**SOLICITATION AMENDMENT
MODIFICATION DE L'INVITATION**

Title - Titre Conversion of Military Vehicles	
Solicitation No - No de l'invitation W6381-23-0003/A	Amendment No – No de la modification 001
Date of Solicitation - Date de l'invitation 29 August 2022	
Address Enquiries to: - Adresser toutes questions à : Name: - Nom : Dennis Lam E-mail : - Courriel : dennis.lam@forces.gc.ca Telephone: - Téléphone : 613-219-5185	
Destination See herein - Voir ci-inclus

Request for Proposal W6381-23-0003/A Amendment 001

Amendment 001 to RFP W6381-23-0003/A is raised to provide responses to questions raised to date and to make updates.

68-34805 Exterior

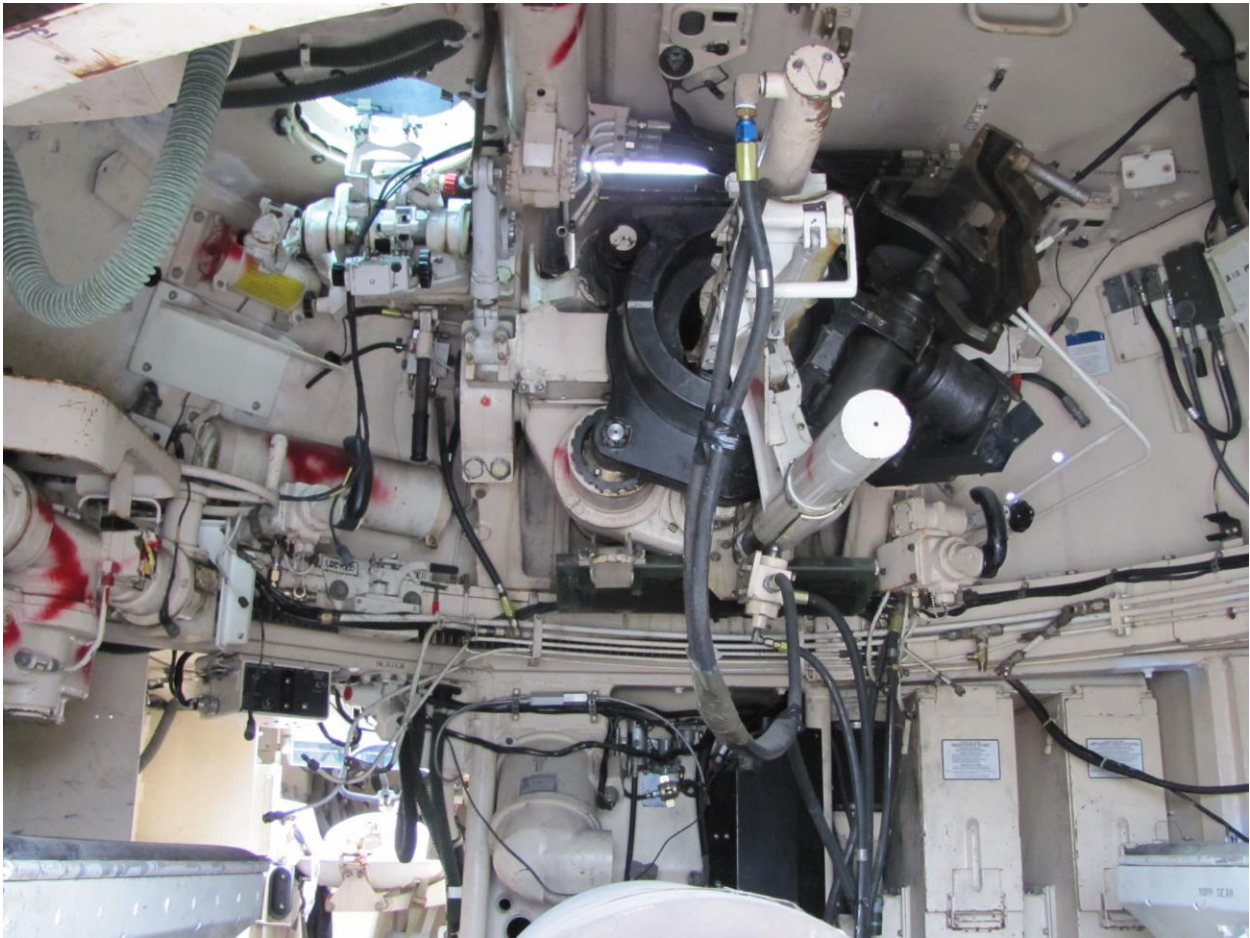
QUESTION 2: Is it possible to visit the vehicles on site in order to inspect their current condition?

ANSWER 2: Site visits are not an option at this time. However, please see Appendix 1 for photos of the actual vehicles which may assist in understanding their current condition.
